Access Compliance Report Public Rights-of-Way (Curb Ramps)

Main Street: ORTEGA_HWY		Cross Street: AVENIDA_LA_PATA		Location:	SE
ADA ID: RPRK211122143737	Ramp Type:Type 1 - Perpendicular	Initial Pass/Fail: Pass	Overall Compliance: No	Severity Score:	9
Codes/Mitigation Info/Possible Solution			Field Measurements/Component Compliance

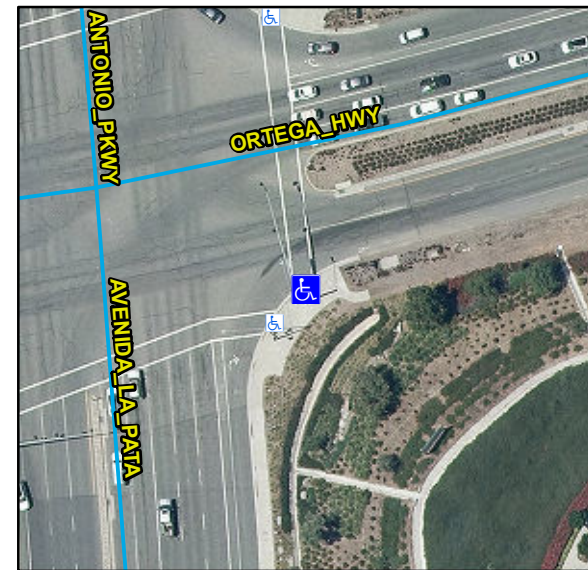
Remove & Replace Entire Ramp. Remove & Replace Gutter. Utility Present.

R304.2.2, R304.2.1, R304.2.2-Perp, R304.3.2-Para, R304.5.3, STD 1115
